GENOA CHARTER TOWNSHIP
Application for Site Plan Review

April 4, 2023

Attention:	Amy Ruthig, Planning Director
Subject:	Tait Eye Center – Site Plan Review #2
Location:	6936 Grand River Avenue – north side of Grand River, east of Euler Road
Zoning:	OSD Office Service District

**Re: Tait Eye Center
Site Plan Review No. 2**

SITE PLAN

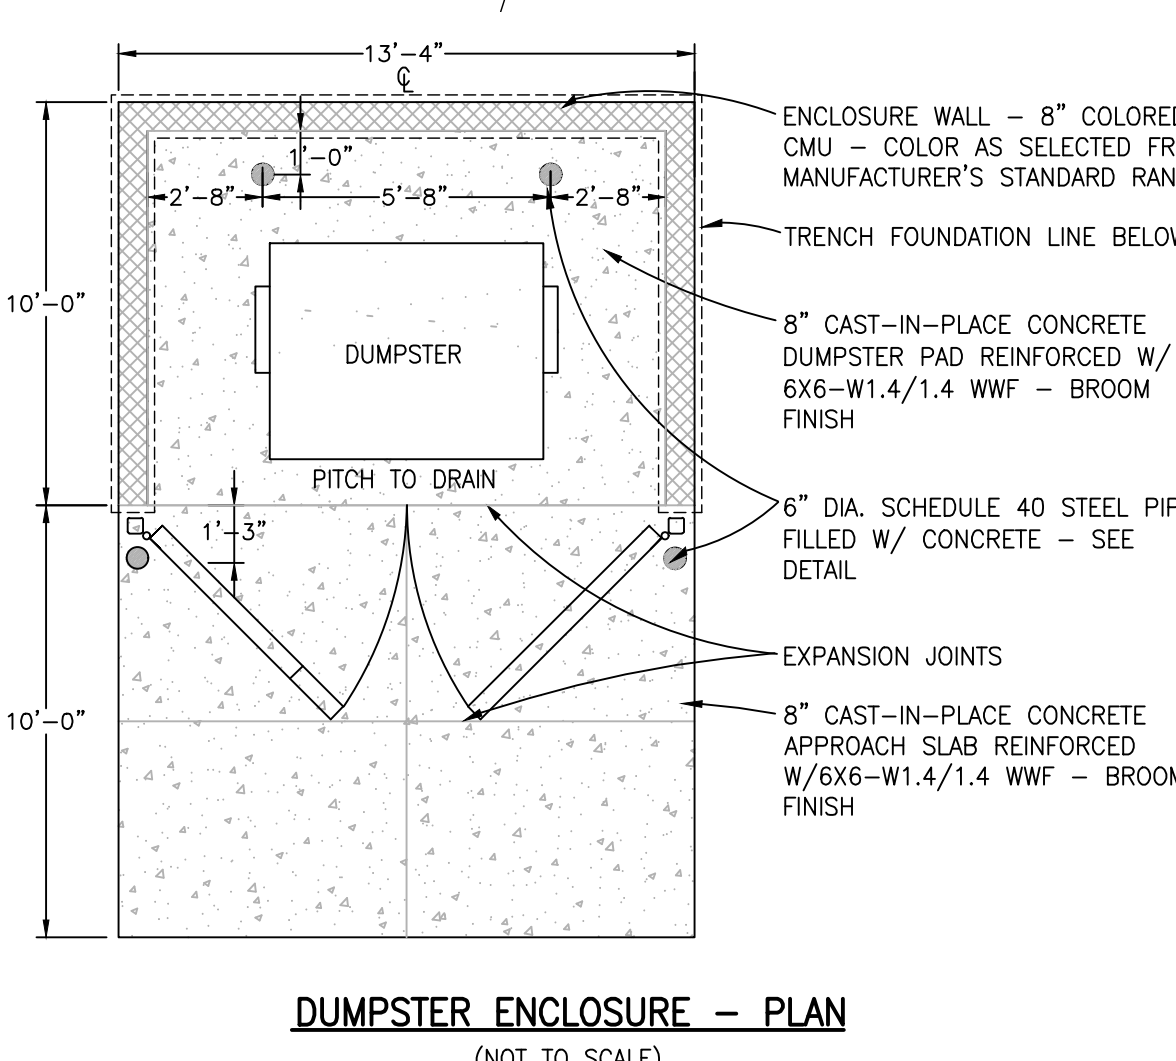
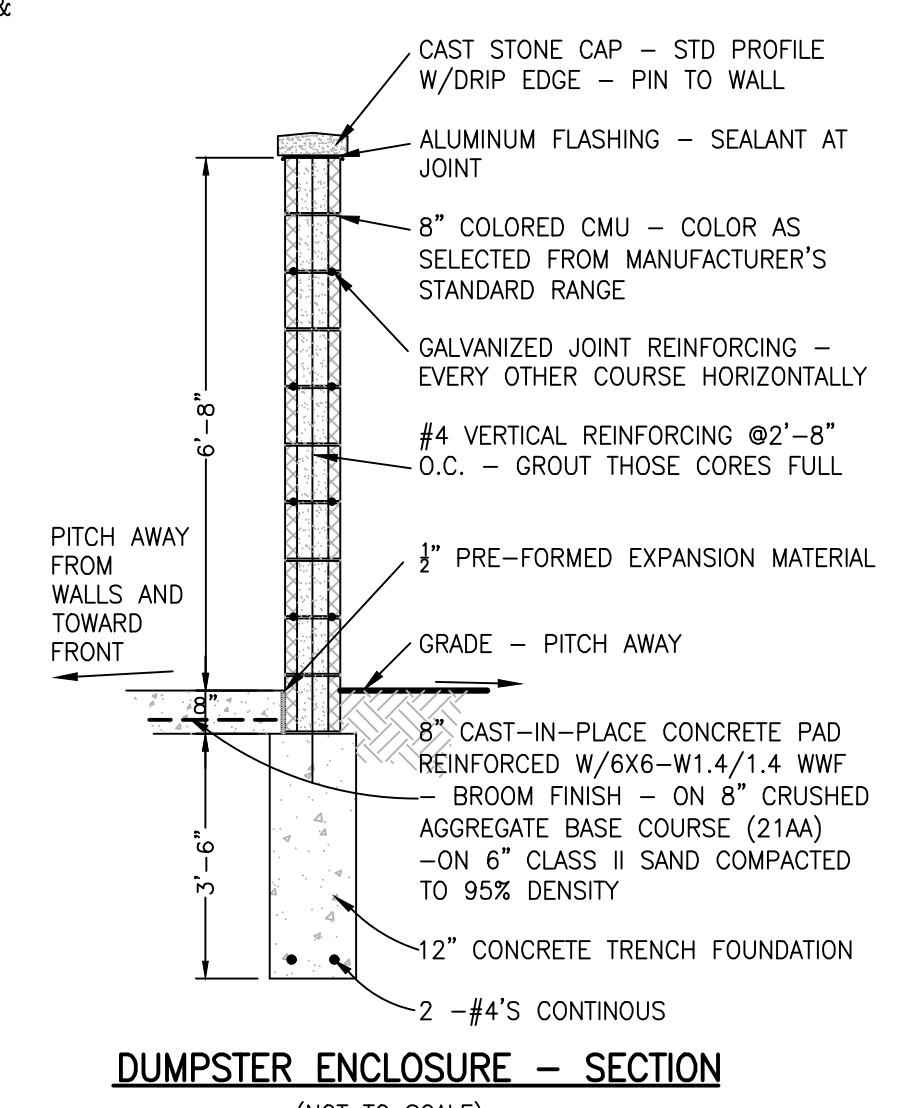
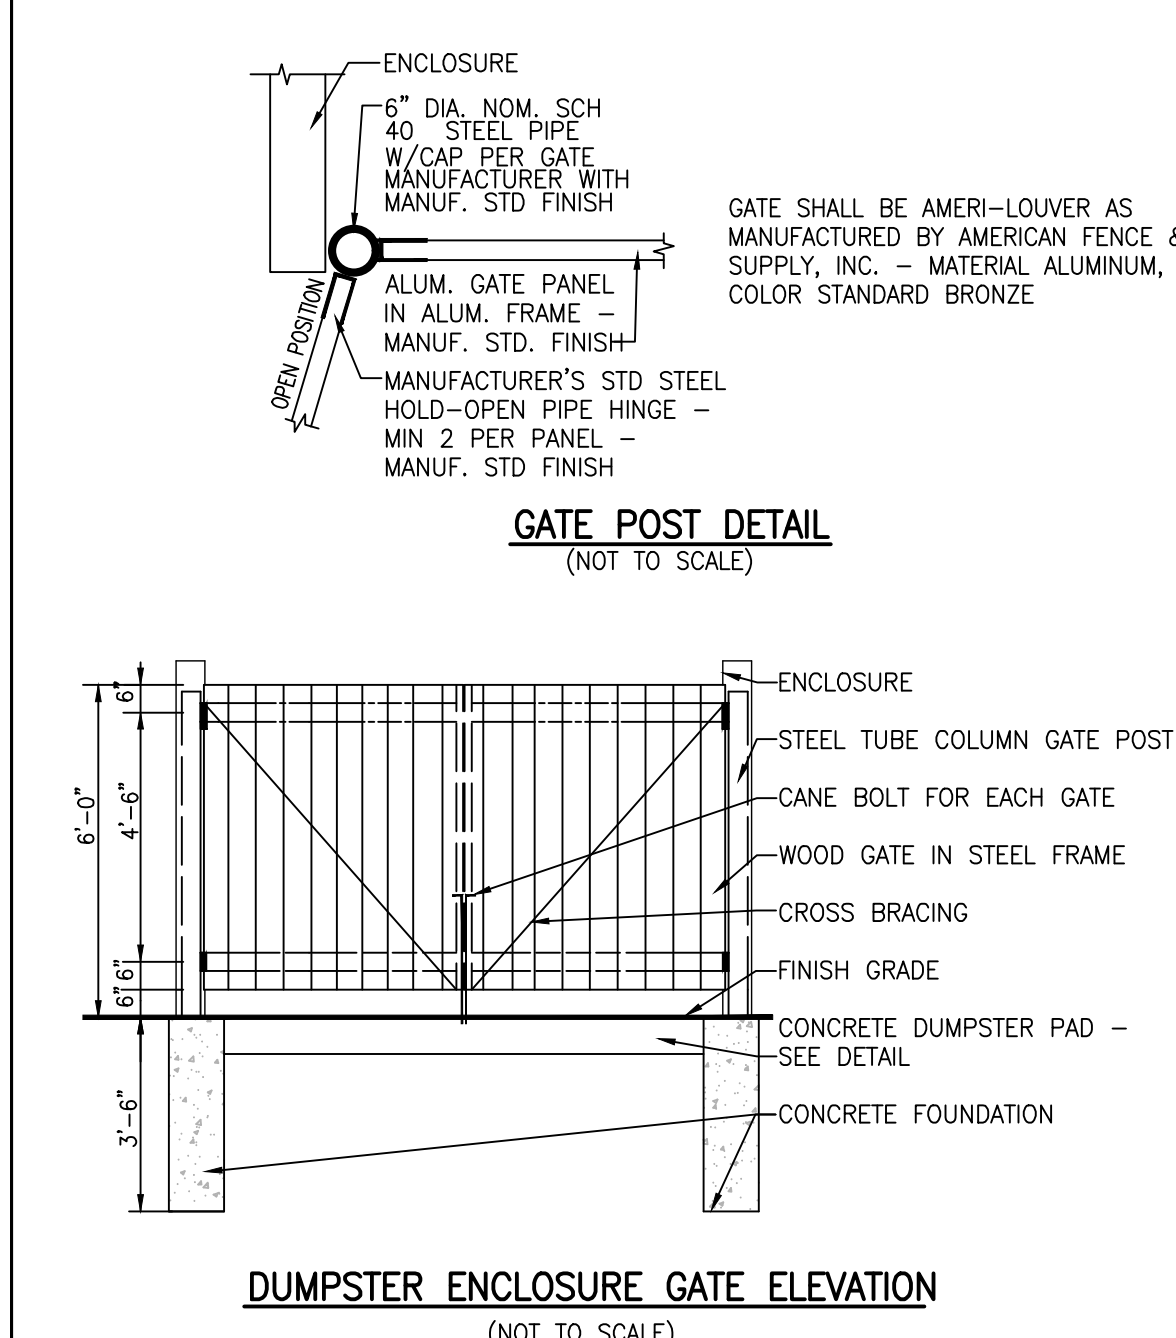
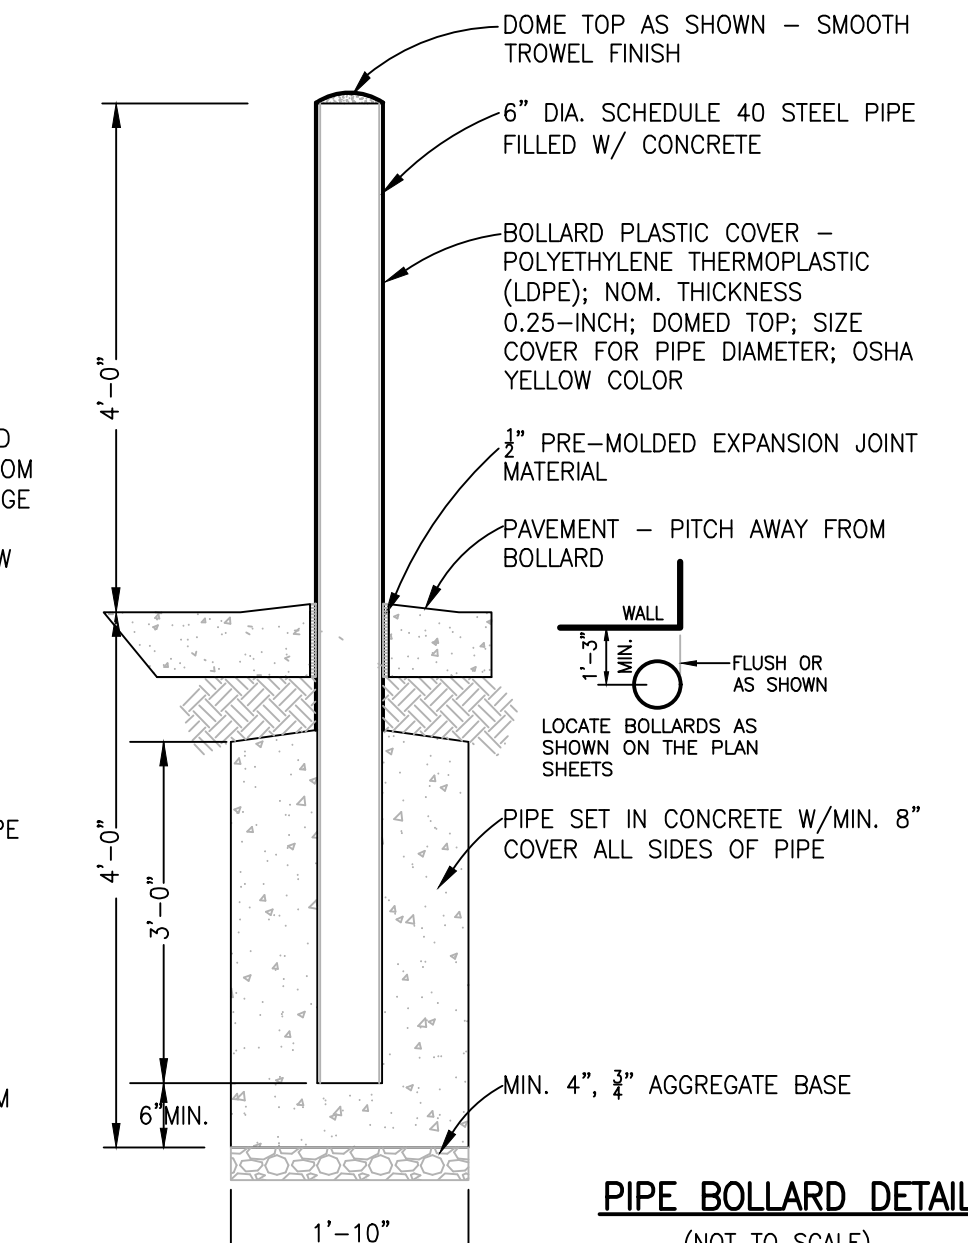
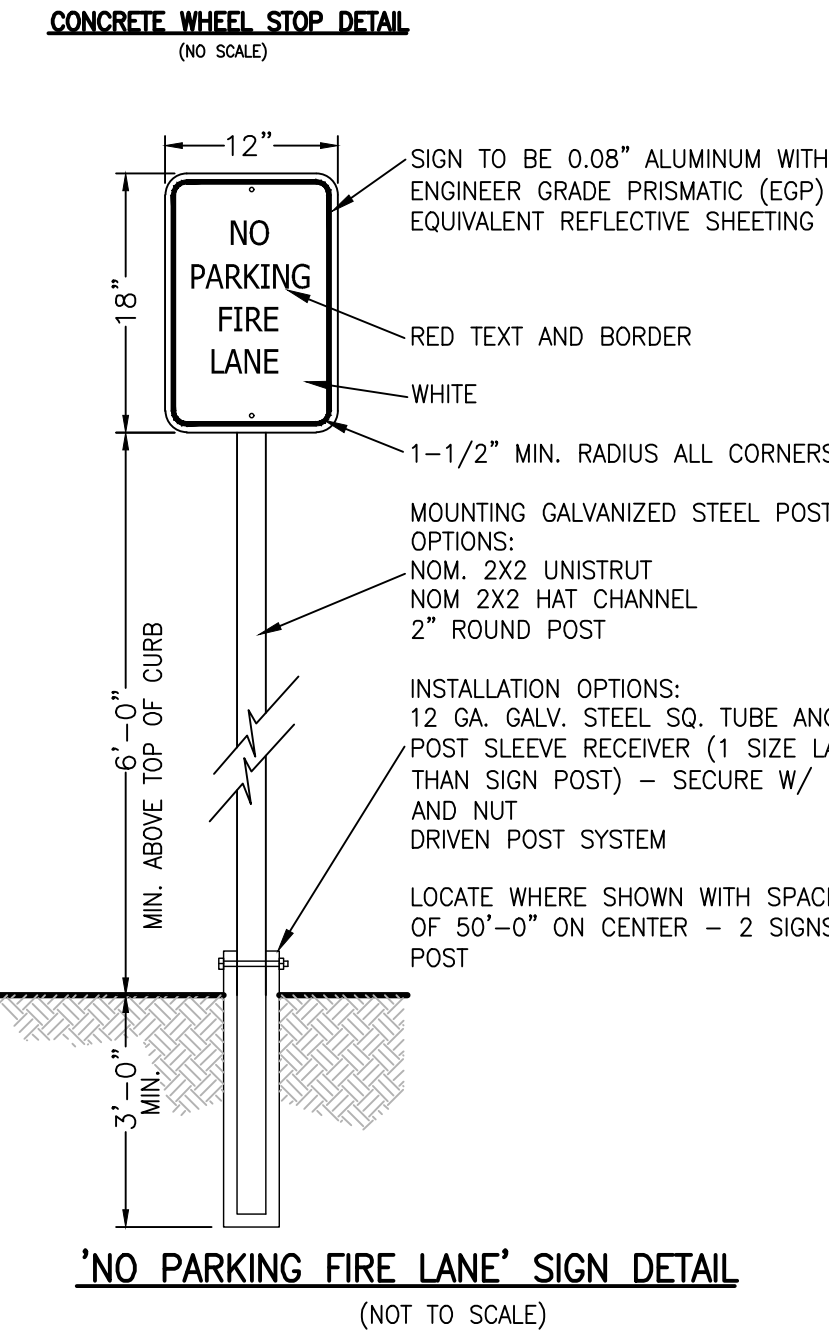
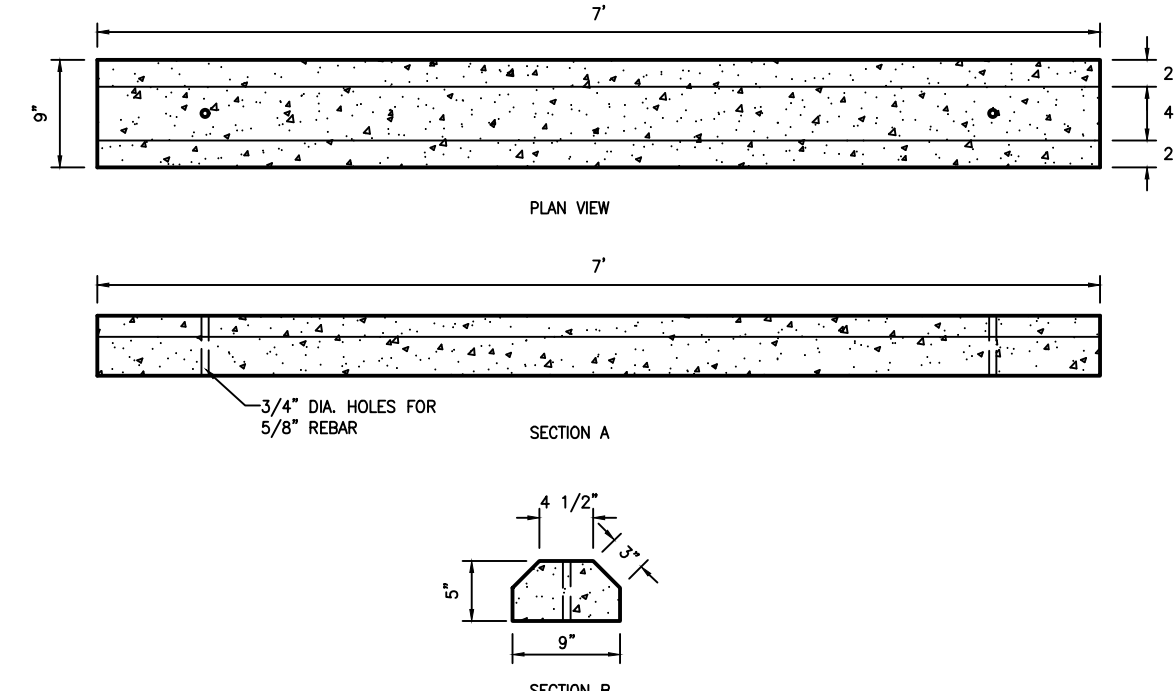
1. The Commission has discretion to reduce the spacing between commercial driveways based on pre-existing conditions (which has been approved by the Road Commission).

5. The plans identify more wall signs than allowed by Ordinance.
6. For the applicant’s reference, electronic message signs are subject to the provisions of Section 16.07.04.

7. The applicant must confirm that a monument sign is allowed within the utility easement (if one is desired).
8. A sign permit must be obtained prior to installation of any signage (i.e., site plan approval does not constitute approval of the signage depicted in the submittal).

The site plan appears to depict an area for a monument sign southwest of the building; however, no details are provided.

1. The site plan shows a proposed fire suppression line, domestic water service, and hydrant. MHOG Sewer and Water Authority will require that the fire suppression line be in a 25-foot public utility easement up to the shut-off valves near the building. After site plan approval, construction plans should be submitted to MHOG for their review and approval prior to construction. The MHOG utility department will need to witness any live taps into the existing water main.

PROJECT: CLARK/TAIT EYE CENTER
PREPARED FOR: TAIT HOLDING, LLC
TITLE: LANDSCAPE PLAN
DESIGNED BY: PC
DRAWN BY: PC
CHECKED BY:
SCALE: 1" = 20'
JOB NO: 22-357
DATE: 02/22/23
SHEET NO. 8

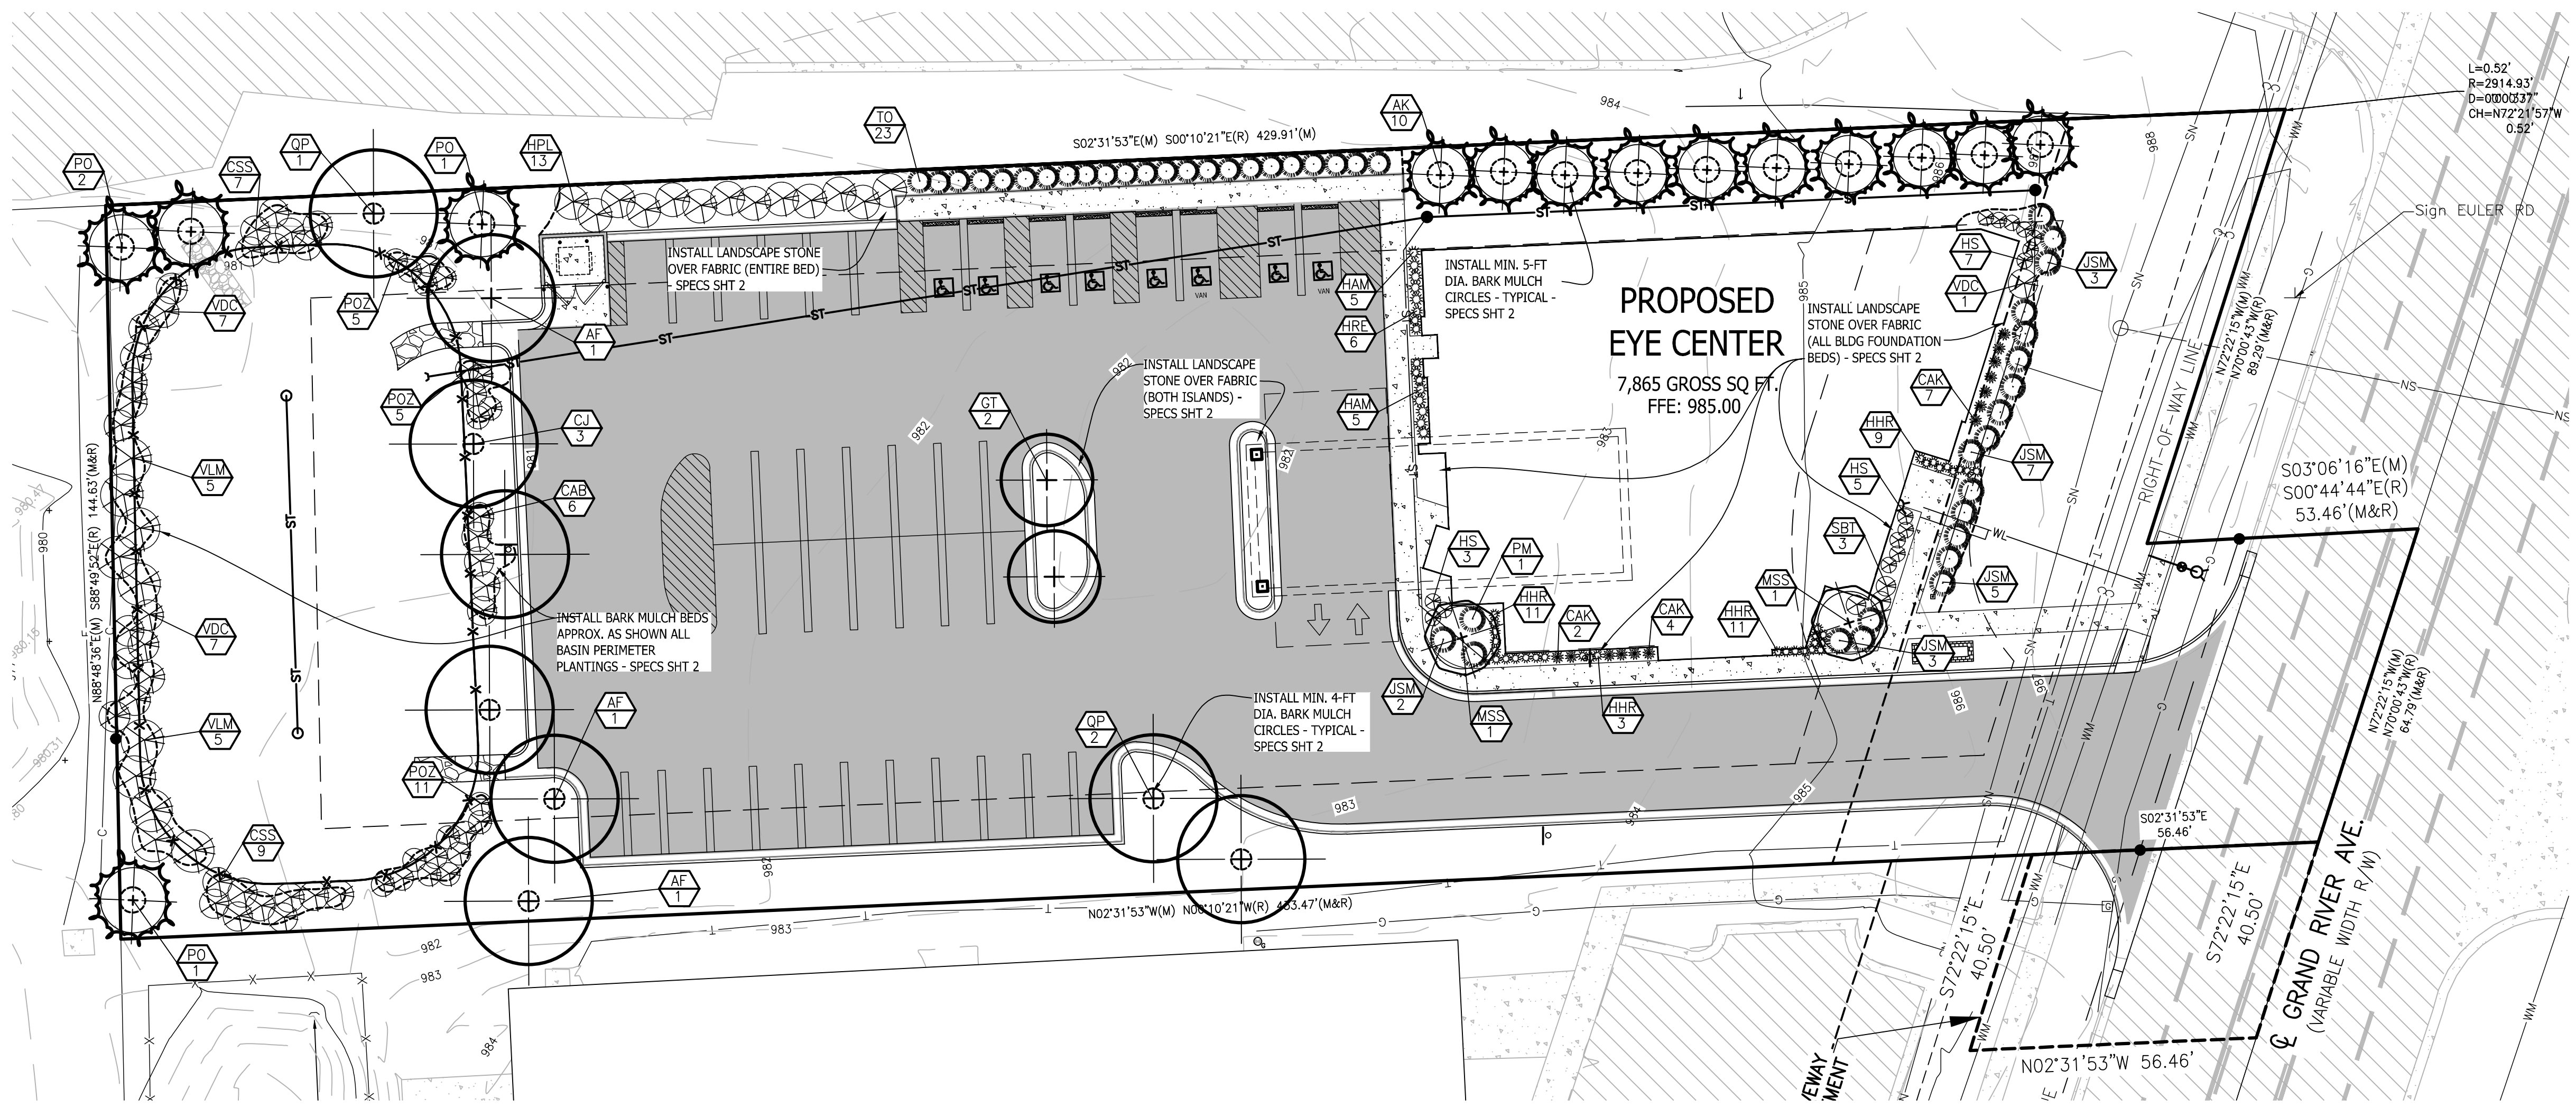
3. The Commission may modify the landscaping requirements for the front yard greenbelt due to the presence of utility easements.
4. The colored CMU on the exterior of the waste receptacle enclosure must match the color of the principal building.

Standard	Requirements	Proposal	Comments
Front yard greenbelt	20' width 4 canopy trees	40' width 1 ornamental tree 34 shrubs	Deficient by 5 canopy trees; however, the front yard contains a utility easement that restricts planting in this area
Parking lot	4 canopy trees 400 SF landscaped area	4 canopy trees 787 SF landscaped area	In compliance
Detention pond	7 canopy OR evergreen trees 66 shrubs	7 canopy trees 4 evergreen trees 67 shrubs	In compliance
